## **Staff Report**

**Subject:** **Considering adoption of Resolution No. 16-65 approving the Downtown Corridors Plan.**

# Downtown Corridors Plan

## Contra-flow bicycle facility

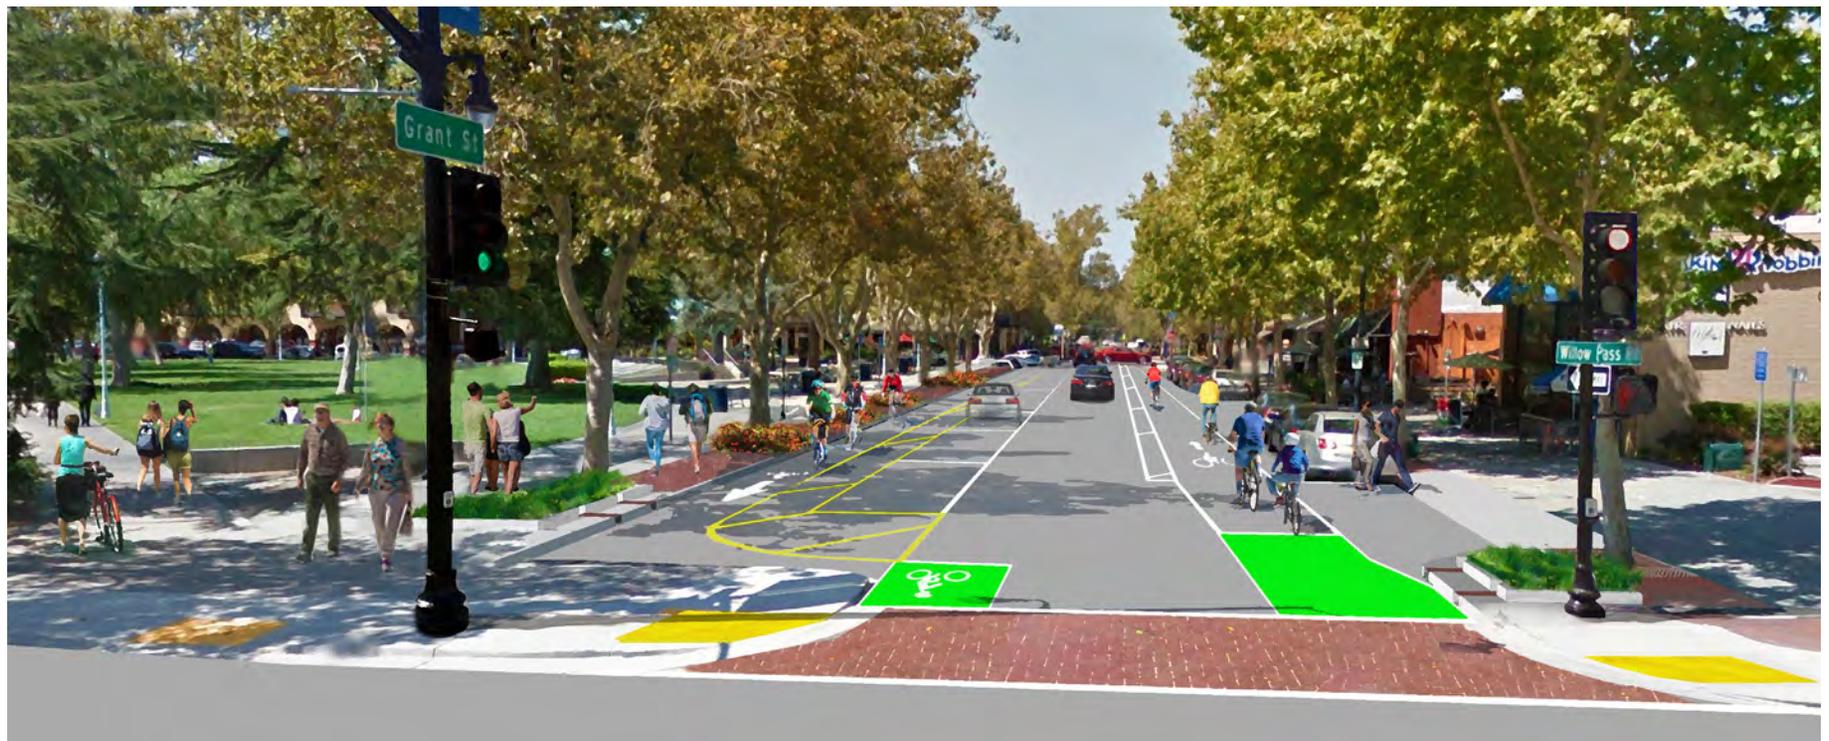
- c. Modifications to the contra-flow bike lane.

The conceptual streetscape design includes a contra-flow bicycle lane on the one-way section of Grant Street between Salvio Street and Willow Pass Road. The contra-flow lane allows cyclists to travel in the opposite direction of vehicle traffic, enabling travel from Todos Santos Plaza south on Grant Street (between Salvio St. and Willow Pass Road) toward the Concord BART Station. The contra-flow bike lane option (#3) that was previously included in the Concept Plan (Todos Santos) was not supported during the City Council review on May 31. The City Council had concerns with drivers being able to back into the reverse angled spaces, the visibility of bicyclists, and concerns with potential conflicts with those vehicles following those cars attempting to back into parking spaces.

*The contra-flow bike lane has been modified from the earlier reverse angle parking concept to parallel parking to address the Council's concerns (further details in next section).*

Staff has worked with the consultant to prepare a new proposal based on Council members' input. The new proposal locates the contra-flow lane between the western curb and parallel parking. The design has less potential conflicts with traffic and does not require modifications to curb bulb outs, as shown in the attached diagram (Attachment 4- 2 pages). Cyclists heading south are protected from northbound vehicle traffic by the parking aisle and a door buffer zone. The downside to this option is that the bike lane on the west side of this one block portion of the street, adjacent to the Todos Santos Plaza, would need to be closed during special events such as the Farmers' Market. To close the lane, it is recommended that the City should place a temporary "Bike Lane Closed" sign at the entrance to the contra-flow at Grant and Salvio Streets during events.

# Oak Street/BART Access Conceptual Plan

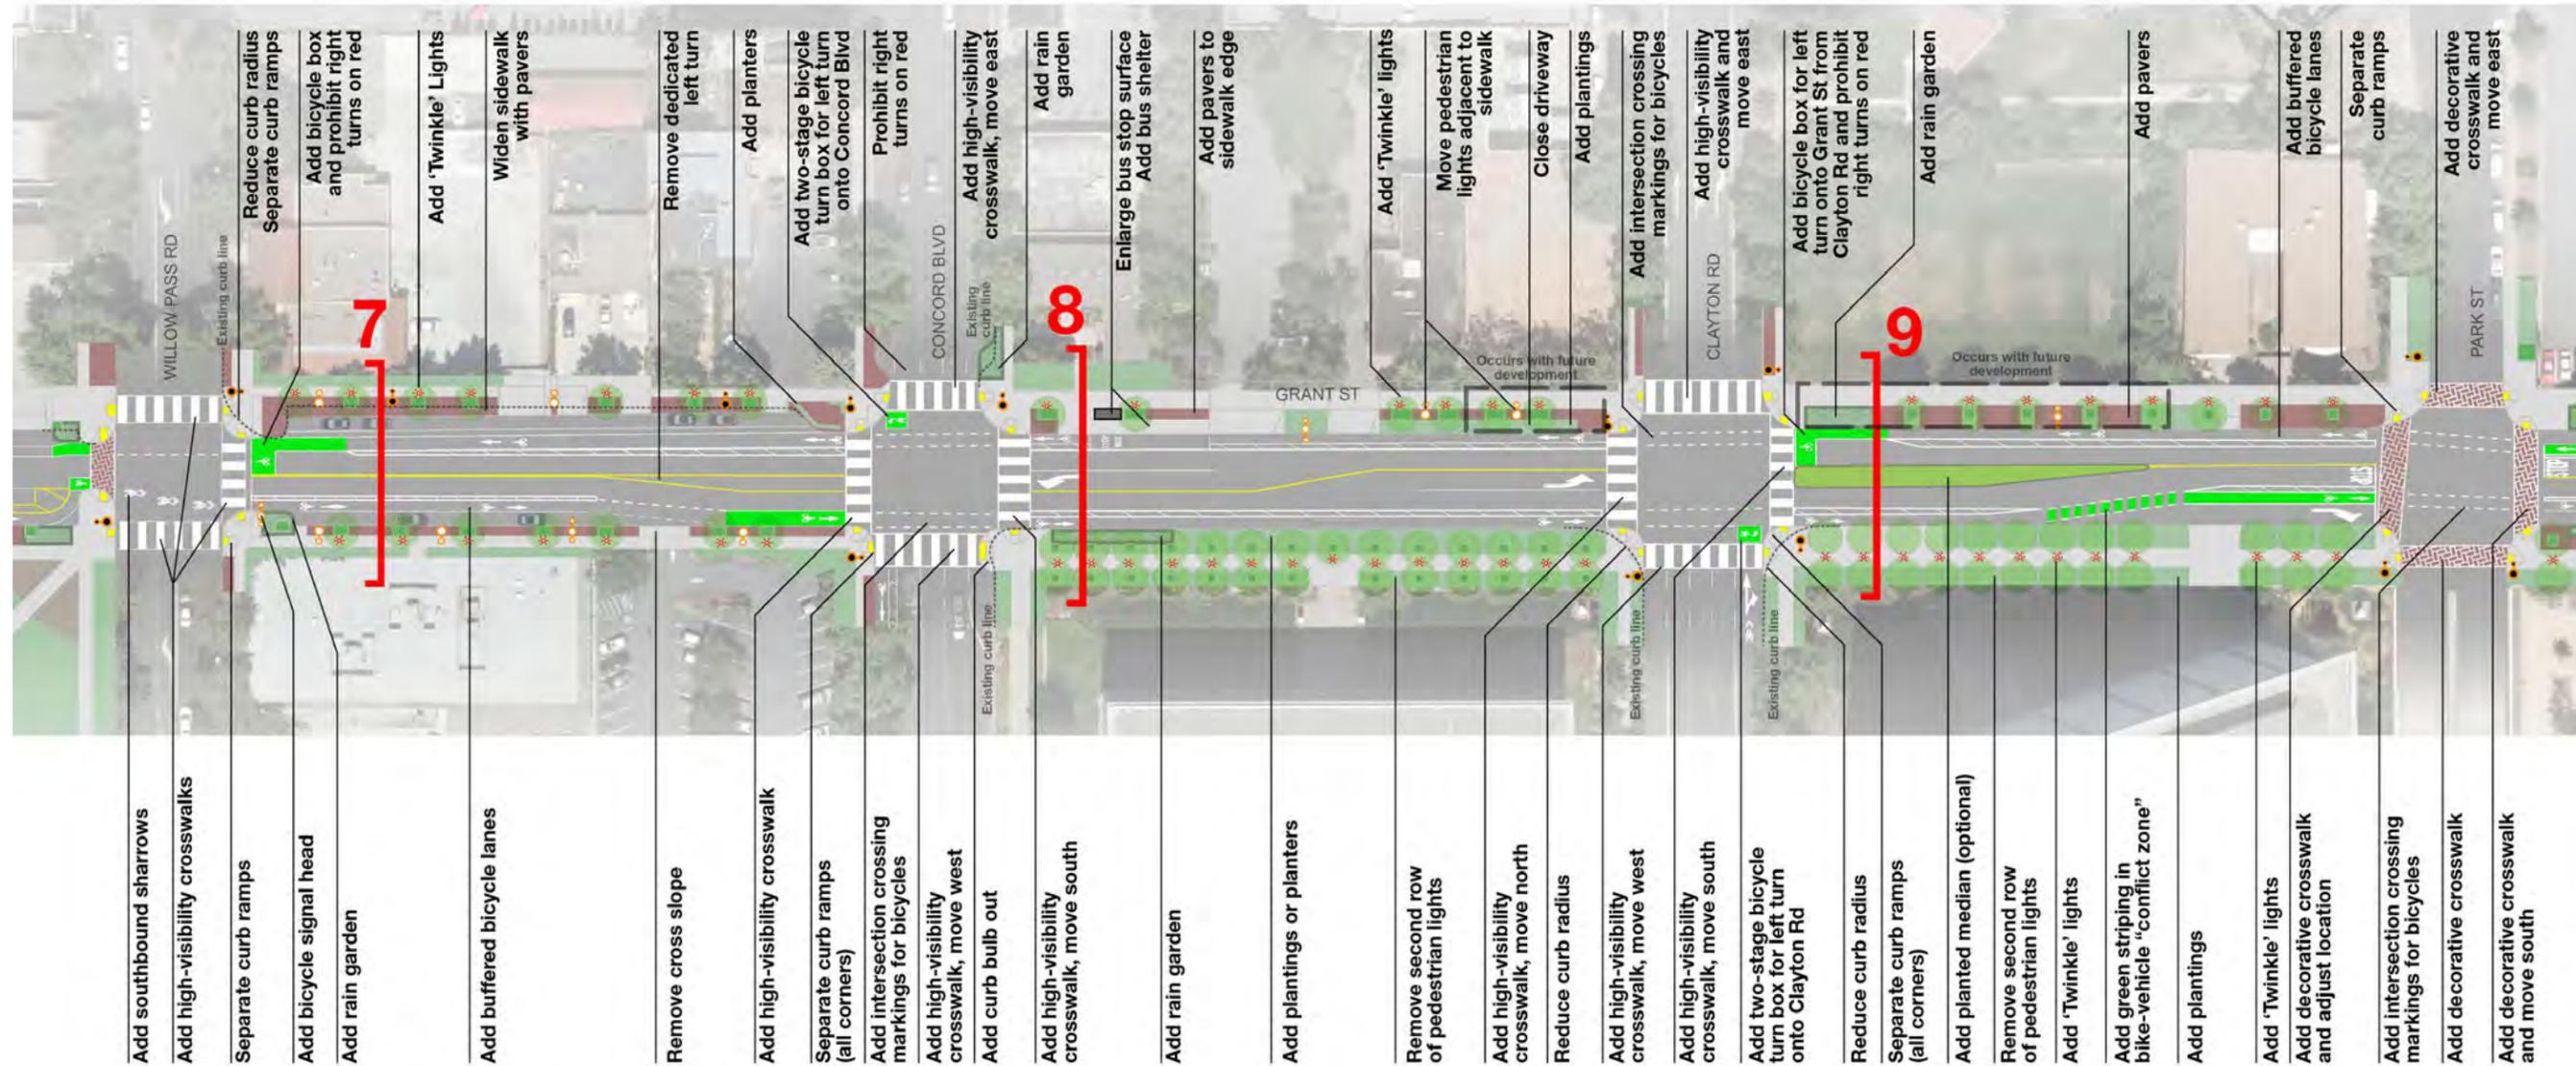
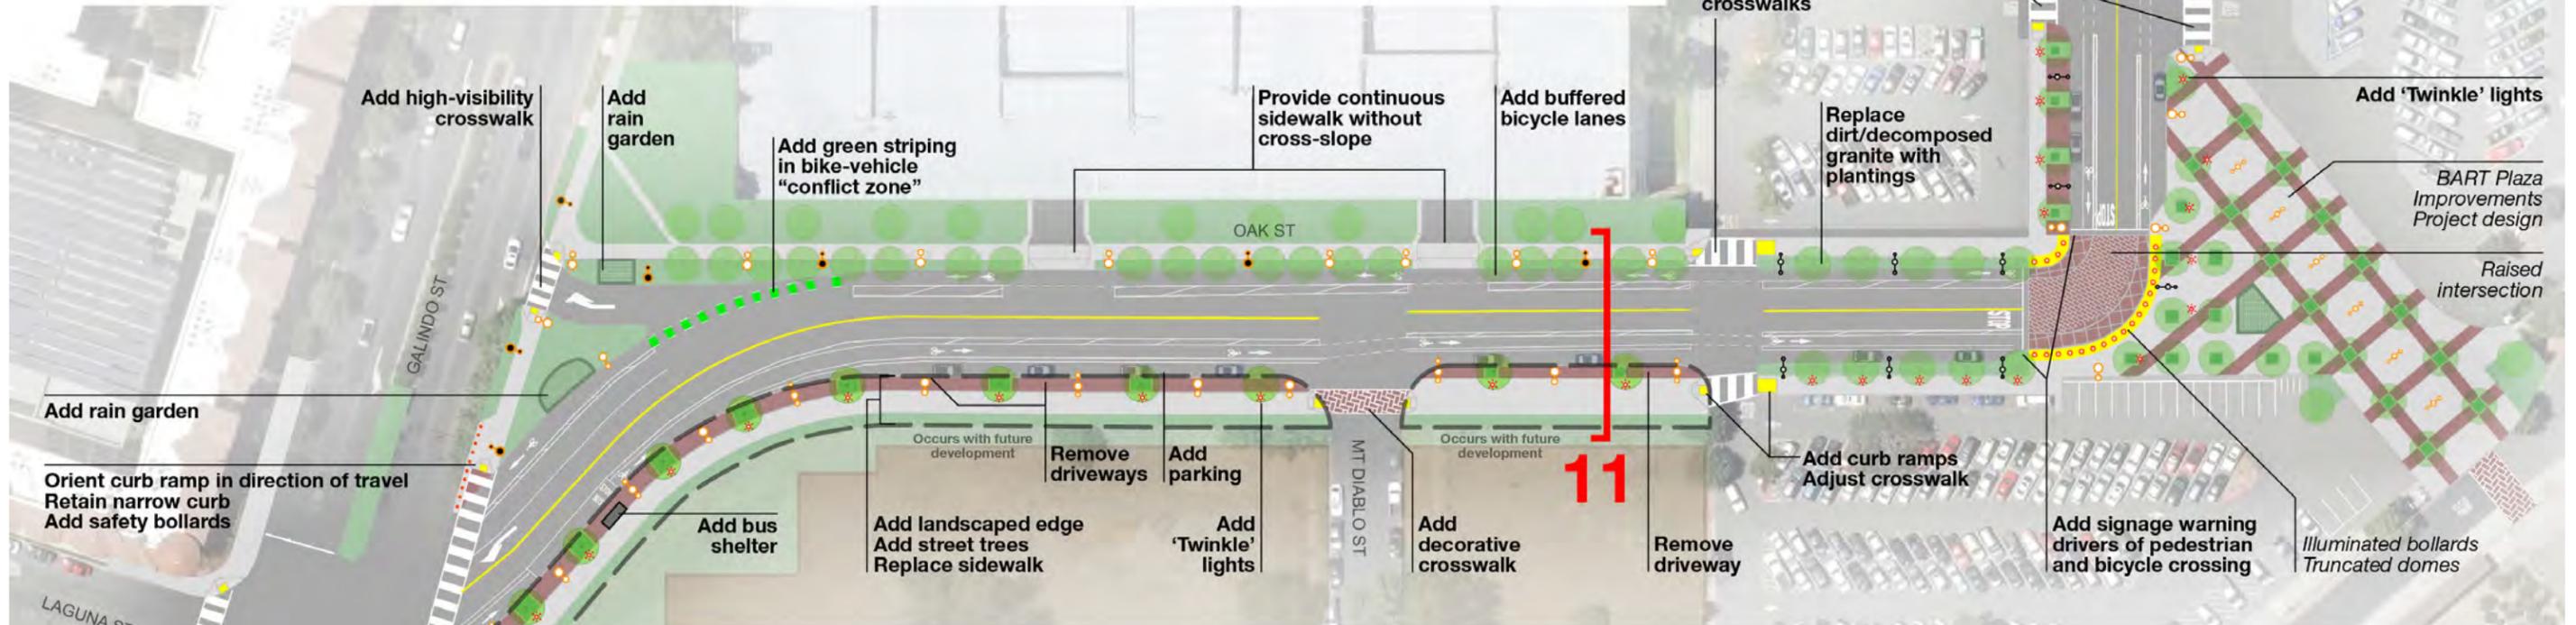
- f. Adjustments on pavement color at Oak St. to clarify vehicular vs. bike areas.

- g. Modification to concept plans to reflect more of the BART Plaza area.

*The bike lane from Oak Street is not intended to go up Galindo Street. The color of the pavement has been modified to reflect this area for vehicular traffic turning from Oak St. to Galindo St. (northbound). Concept Plan has been modified. Grant St. is intended as the north-south bicycle street, per the Specific Plan.*

*The Oak Street Concept Plan has been modified to show additional area of the BART plaza.*

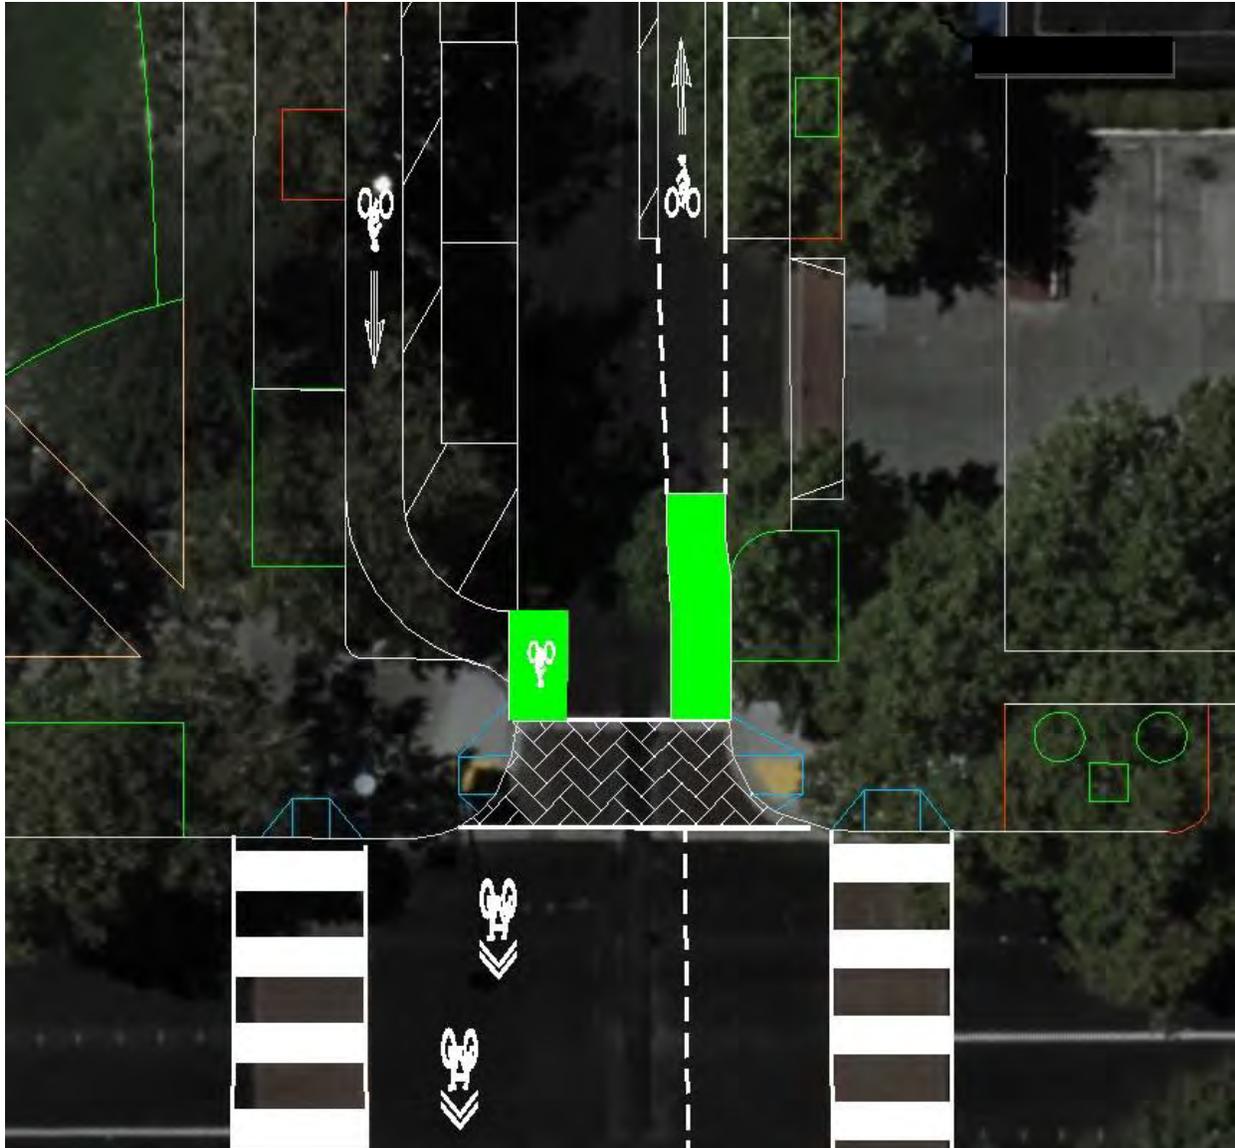
The green painted bike lanes leading up to bike boxes, in the contra-flow bike lane, or highlighting crossing movements ahead of turn pockets are well implemented. The solid green paint used in the bike lanes on Grant St. before the intersections with Concord Blvd. (N and S), Clayton Rd. (S), and	<i>The Transportation Manager has reviewed and agrees that this can and should be done. Concept plans have been modified to make the change. Park St. (N) was retained to highlight a potential conflict zone.</i>

<p>Park St (N) does not seem to have a specific purpose though, and that portion of paint could be removed to reduce cost. If paint is maintained it should be dashed, not solid, at locations where drivers are allowed to make right turns.</p>	
---	--
